November 29, 2021
File: 213402602

**Reference: Response to Public Comments
Remedial Investigation Report Addendum,
Area of Interest 4
Sitewide PADEP Facility ID No. 780190
AOI 4 eFACTS PF No. 770318
Former Philadelphia Refinery
3144 Passyunk Avenue
City of Philadelphia
Philadelphia County**

See id., Figure 4-1e - Unconfined Aquifer Elevation April 2021, with Penrose Ave Remediation system polygon, line and point features superimposed. Other areas of AOI-4 and adjoining boundaries should be overlain similarly.

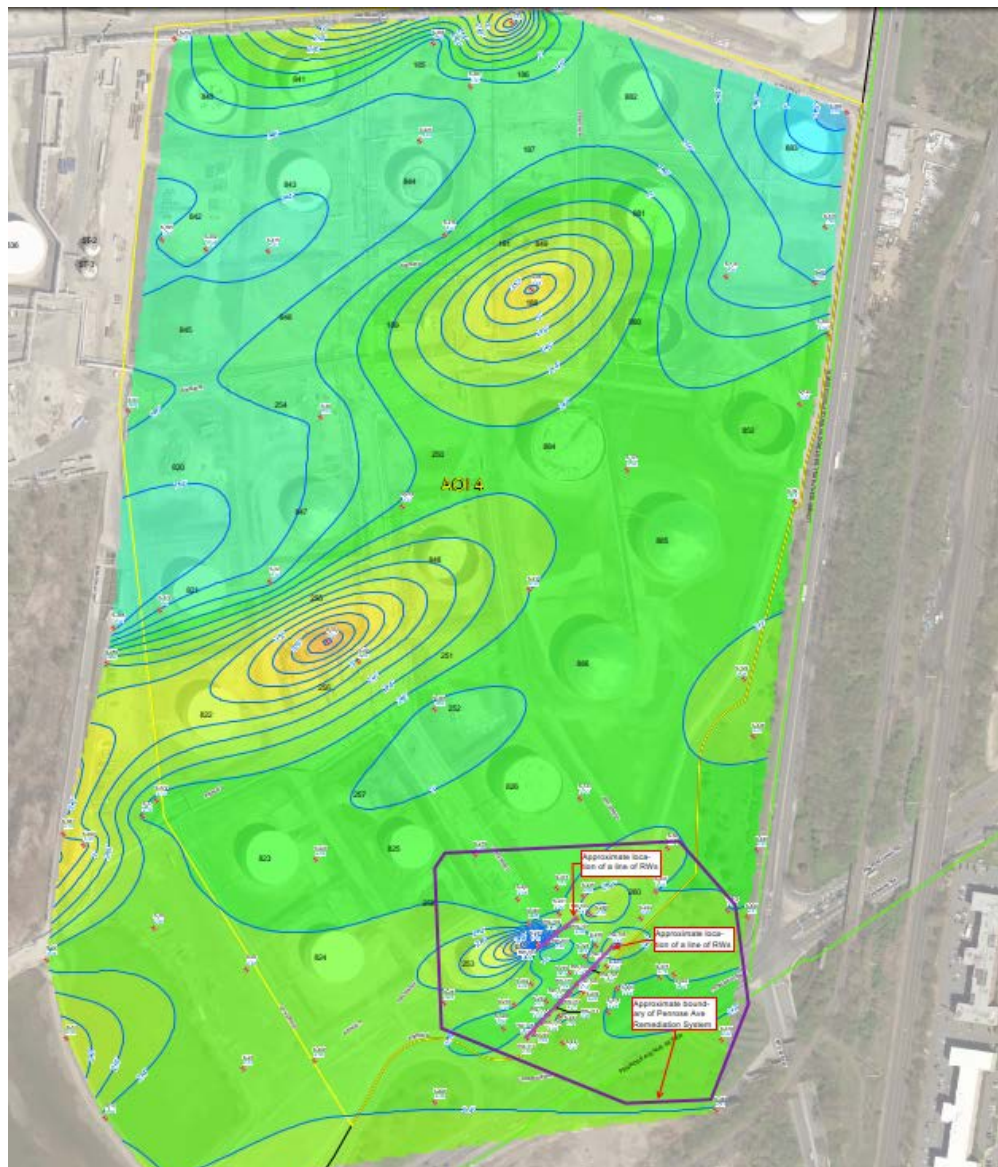
Cross referencing Figure 4-1e with the location of the Penrose remediation system and extraction points, it appears that potential groundwater mounds centering on shallow monitoring

wells (S-104, S-96, S-371) are not explained. Perhaps remedial systems, perching conditions, well construction or other factors can be attributed to the contours surrounding these wells taking a mounding shape. But this should be analyzed.

Such overlays may also help to explain the shapes of other areas contoured on Sunoco Figures 4-1a through 4-1e (perhaps with mounded, drawdown, convergence around sewers, or other unexplained shapes). An example of an overlay for the Penrose remediation system is shown below superimposed on Figure 4-1e:

Other comments pertaining to the water table include the potential for mounding in AOI 4 and the extent of data presented in each RIR Addendum figure. In review of the figures, Evergreen found that Figures 4-1c and 4-1d were missing well S-369 data. Those figures have been revised and attached to these comment responses. Note that the inclusion of well S-369 data does not substantially change the flow pattern or conclusions presented. The differences in data extent are due to the available well gauging data for each event. Two events were performed specifically to inform the Penrose area of AOI 4 (November 2018 and December 2020). Note that Evergreen does not have access to routinely gauge offsite wells owned by others for the former DSCP facility; however, an effort is made by both parties to share well gauging data and to coordinate synoptic gauging events when possible. The topography in AOI 4 is inherently flat and thus the water table is characterized by a subtle and subdued pattern with shallow gradients. A small contour interval was used in the AOI 4 RIR Addendum figures to evaluate the conditions and can give the perception that gradients are larger than what they are. The April 2021 data for wells S-104 and S-96 are called out as examples and are found to be within the reasonable range of historic data.

Figure 39. The Defense Supply Center Philadelphia/Point Breeze Refinery area showing selected observation wells, selected grid cell locations, and the Packer Avenue sewer.

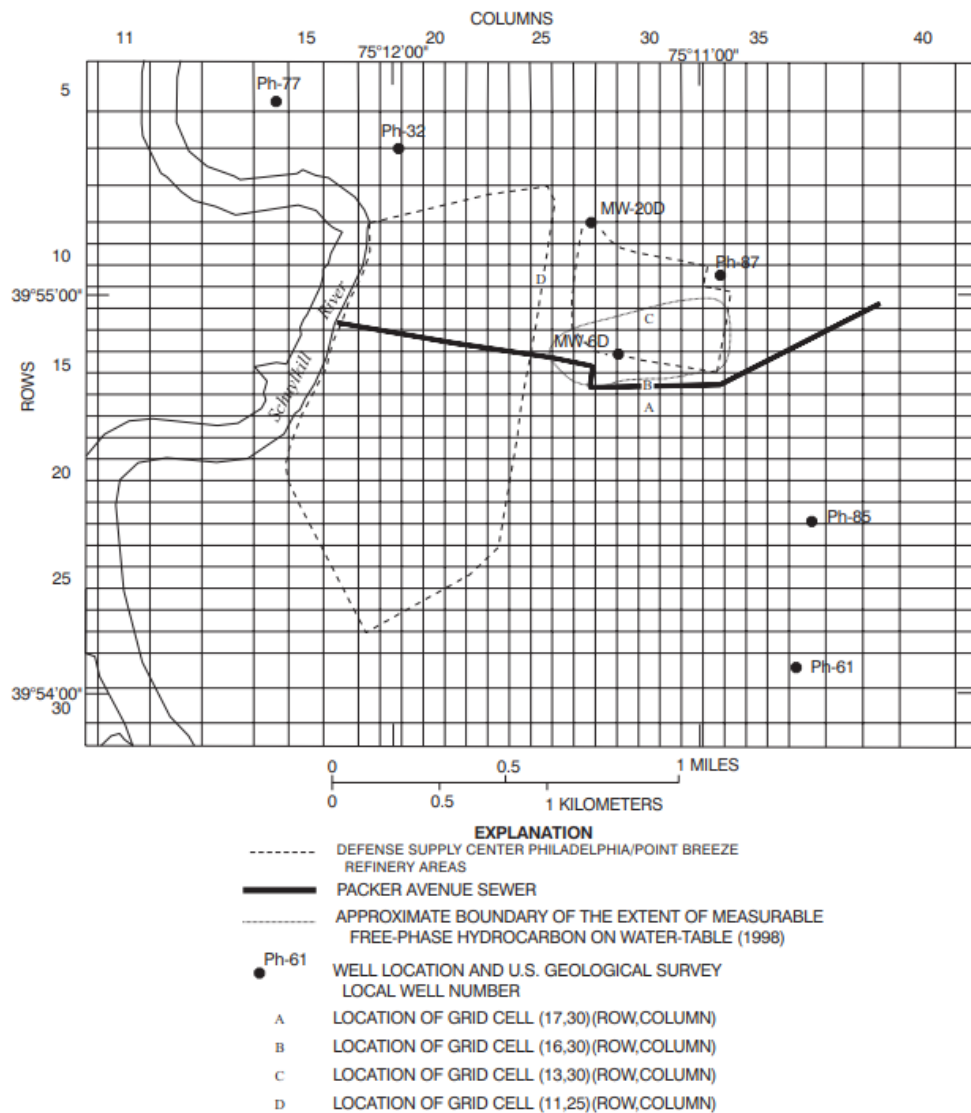
Because historical ground-water-flow directions were predominately to the southeast, the Packer Avenue sewer would have been a barrier to hydrocarbon plume migration to the southeast from 1900 to 1947. Subsequent to 1947 through 1995 the hydrocarbon plume could have been migrating to the southeast, unimpeded by the sewer. Also, the simulated hydrographs on figure 47 show the consistent lower head in layer 7 (compared to layer 1) at cells 16,30 and 17,30, which indicates downward vertical ground-water-flow gradients.

Response to Comment #4: Based on the well gauging data and interpolations presented in the RIR for Figures 5-2 through 5-4, the pattern of groundwater flow in the unconfined aquifer in the vicinity of monitoring well S-369 indicates convergence along 26th Street. The pattern supports that the 26th Street Intercepting Sewer is inherently leaky along this section of the sewer and that the sewer is an exit point for groundwater on both sides of 26th Street. At the neighboring ARCO property, the inferred groundwater flow direction is from the east. The developed property on the southeastern corner of 26th and Hartranft Streets is a former Ryder LC facility (Ryder). Figure 2 presents a contour map of groundwater gauging data for June/July of 2008 for the complex, former Ryder property (ROUX, 2008), and the Defense Supply Center Philadelphia (DSCP; Tetra Tech, 2008). This map indicates that a similar groundwater flow pattern was present in 2008 and has persisted through time in an area where several potential sources of groundwater

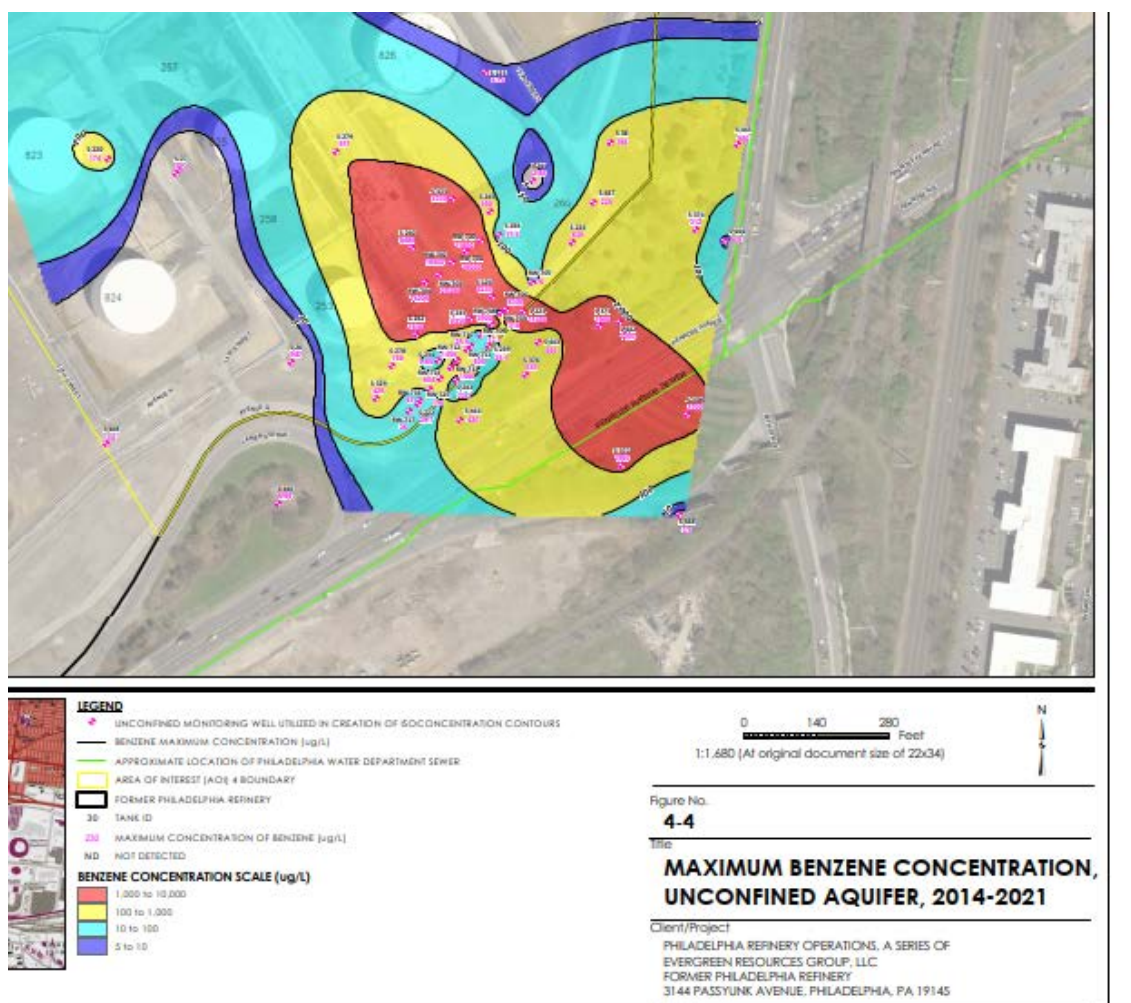
Based on a review of the guidance documents, Evergreen has not established that the number, placement, and manner of installation of wells is sufficient to address off-site migration even near the Penrose Avenue Remediation System.

See 2021 Addendum Report (AOI-4), pdf page 166 of 307, Figure 4-4 (Maximum Benzene Concentration Unconfined Aquifer, 2014-202).

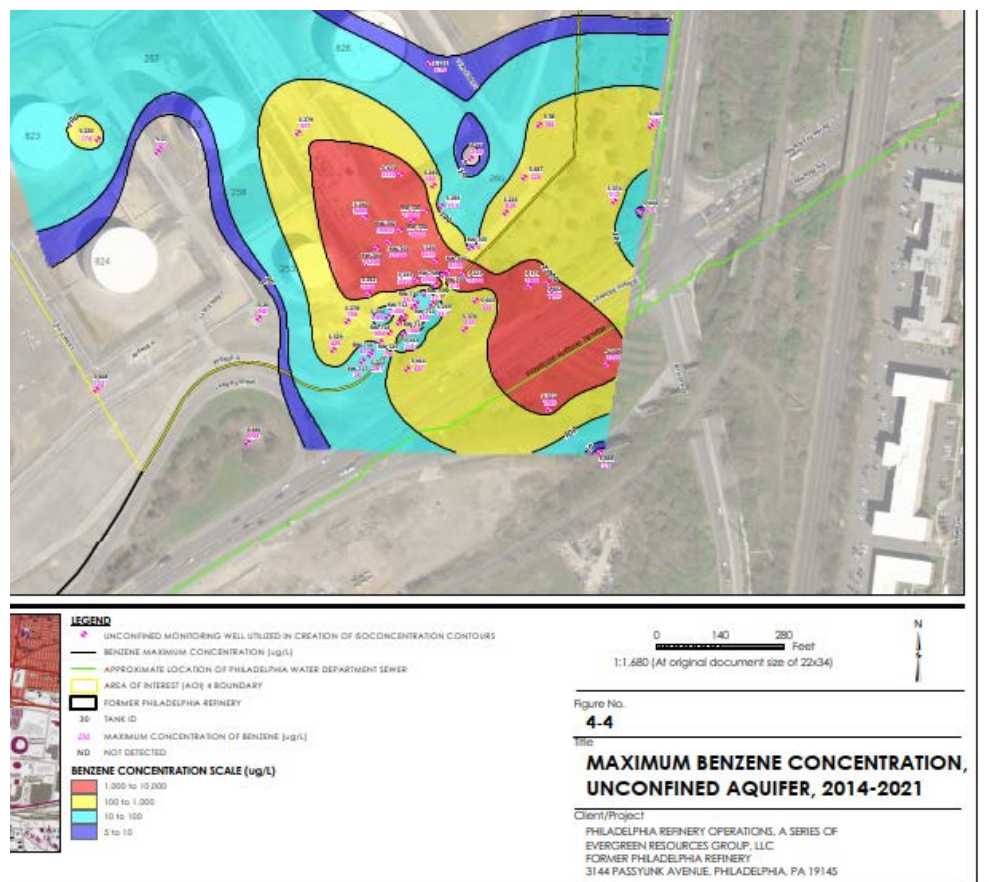
The effects of Penrose Avenue and Lower Schuylkill East Side Intercepting sewers on the migration of contamination would be critical to understanding groundwater flow and support Sunoco's placement of monitoring wells. In fact, the contamination mapping shows benzene to be migrating beyond the sewer as shown below in Figure 4-4:

Sunoco's Figure 4-4 maximum benzene concentration unconfined aquifer 2014 - 2021 groups the highest benzene concentrations onto a single map. Mapping isoconcentration in this manner does not illustrate how the contamination plume has changed in time over the period 2014 through 2021.

- Figure 4-4 presents an updated maximum benzene concentration map for the AOI 4 unconfined aquifer for the period 2014-2021 (period overlaps previous RIR datasets but is consistent with the data being used for Evergreen's Sitewide Fate and Transport RIR). Figure 4-7a displays benzene and other exceedances for samples collected since the AOI 4 RIR. The pattern of benzene impacts above the SHS indicate source(s) spatially related to areas where LNAPL has previously been observed in wells, and where tankage records indicate a long history of refinery product storage. In the area southeast of AOI 4, the estimation of benzene concentration has been extended offsite using the new sample dataset maximums. The well data consistently indicates an offsite area of elevated benzene in groundwater with an offsite core centered across Penrose Avenue including wells S-375, S-377, and S-378. Decreases in benzene maximum concentrations of up to three orders of magnitude to concentrations below the SHS are demonstrated for wells S-440, S-448, S-444, and S-446. Groundwater data from Provco property wells for November 2018 indicate flow towards Penrose Avenue converging around the Penrose Avenue Sewer (see Figure 4-1a), and 2017 Provco well analytical data, available for select wells shown in the figure, indicate non-detects or low-level benzene detections. These conditions support delineation in that direction. Given benzene concentration data alone, wells S-378 and S-445 may not demonstrate sufficient delineation on the east side of the area; however, the forensics data discussed in the next two bullets provides the important lines of information supporting the presence of offsite benzene source(s).
